Access Compliance Report

Public Rights-of-Way

(Curb Ramps)

Intersection ID: 29966	Main Street: PANOS_DR	Cross Street: W_W_T_HARRIS_BV	Location: NE
ADA ID: B558F10C2B60	Ramp Type: Perp	Initial Pass/Fail: Fail	Overall Compliance: No
			Severity Score: 10

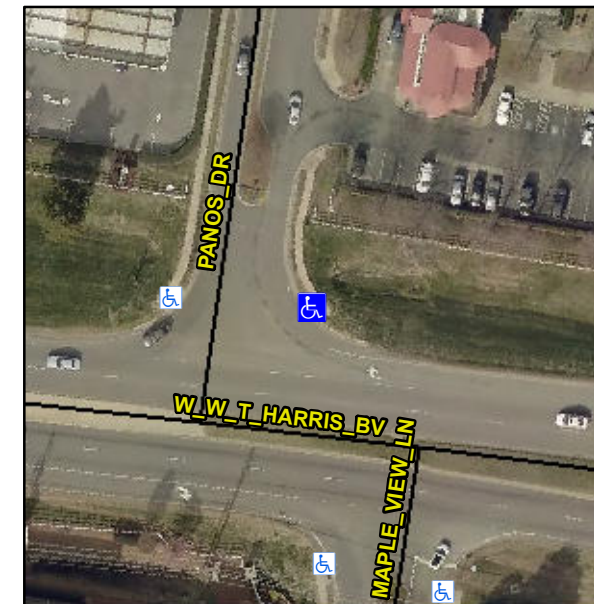
R304.5.1, R304.5.3

Compliance	Description	Data	Compliance	Description	Data
N/A	Ramp Length (in)	49.0	Yes	Ramp Slope (%)	2.9
No	Ramp Width (in)	45.0	No	Ramp XSlope (%)	3.3
N/A	Flare Type LT	N/A	N/A	Flare Type RT	N/A
N/A	Flare Slope LT (%)	N/A	N/A	Flare Slope RT (%)	N/A
N/A	Flare Traversable LT?	N/A	N/A	Flare Traversable RT?	N/A
N/A	Landing Length (in)	N/A	N/A	DWS Provided?	N/A
N/A	Landing Width (in)	N/A	N/A	DWS Contrast?	N/A
N/A	Landing Slope (%)	N/A	N/A	DWS Length (in)	N/A
N/A	Landing X Slope (%)	N/A	N/A	DWS Full Width?	N/A
N/A	Landing Curb? (Y/N)	N/A	N/A	DWS Offset (in)	N/A
N/A	Shared Landing?	N/A			
N/A	Gutter Ponding?	N/A	N/A	Gutter Slope (%)	N/A
N/A	Gutter Lip Ht (in)	N/A	N/A	Gutter X Slope (%)	N/A
N/A	Painted X Walk1?	No	N/A	Painted X Walk2?	N/A
	X Walk 1 Direction	To W		X Walk 2 Direction	N/A
N/A	X Walk 1 Width (in)	N/A	N/A	X Walk 2 Width (in)	N/A
	X Walk 1 Slope (%)	0.7		X Walk 2 Slope (%)	N/A
	X Walk 1 X Slope (%)	5.6		X Walk 2 X Slope (%)	N/A

Remove & Replace Entire Ramp.
